**Comments on the Environmental Impact Assessment Report for Tuen Mun South
Extension (EIA-279/2022)**

The Hong Kong Bird Watching Society (HKBWS) would like to express our concerns regarding the environmental impact assessment (EIA) report for the Tuen Mun South Extension.

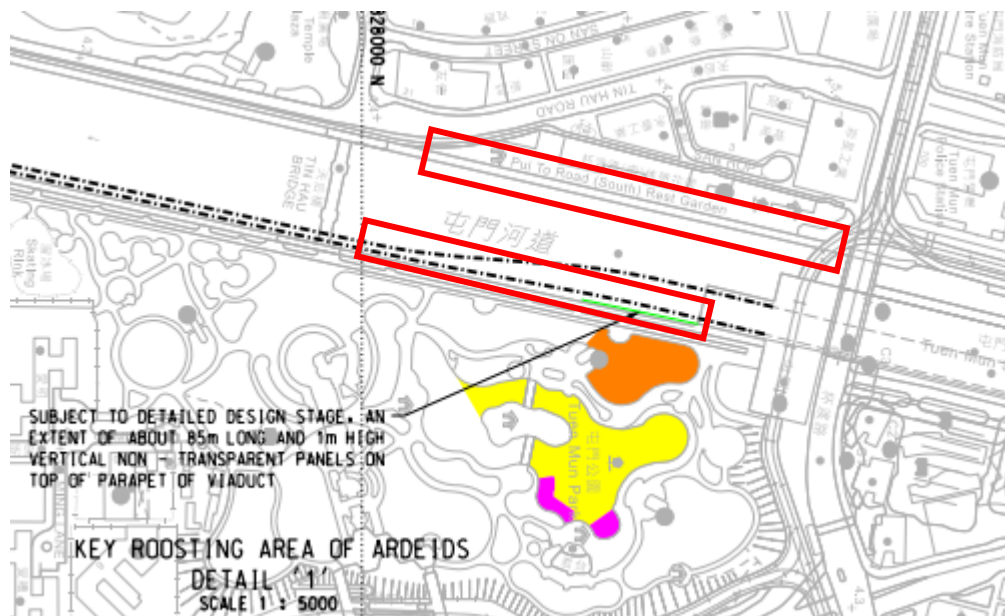
It is mentioned in Section 8.5.18 that “*roosting behaviour of Black-crowned Night Heron was also recorded during daytime at the eastern edge of the artificial lake in Tuen Mun Park*”. Based on our observation, the vegetation at the sides of TMRC has also been utilized for day roosting by Black-crowned Night Herons (Figure 1). However, the ecological baseline surveys did not adequately identify the extent and distribution of the day-roosting sites. More importantly, it is proposed to remove the existing trees at the river banks near Pui To Road (South) Rest Garden as indicated in Figure no. C1502/C/TME/ACM/M57/121. Potential direct loss in roosting ground is thus anticipated.

Besides, there is no information showing their number and flight paths. We are concerned the impacts of obstruction of flight lines on the roosting ardeids are seriously underestimated or even ignored. We consider the proponent should re-assess the impacts on day-roosting ardeids and provide measures to avoid and minimize the impacts on them.

Figure 1. The map below was extracted from Figure no. C1502/C/TME/ACM/M56/108. Apart from the day roost site identified by the proponent, the vegetation at river banks especially near Pui To Road (South) Rest Garden has also been utilized by Black-crowned Night Herons for day roosting based on our observation. However, the ecological baseline surveys did not adequately identify the extent of the day-roosting sites. More importantly, the proponent proposed to remove the existing trees near Pui To Road (South) Rest Garden. Potential direct loss in roosting ground is thus anticipated.
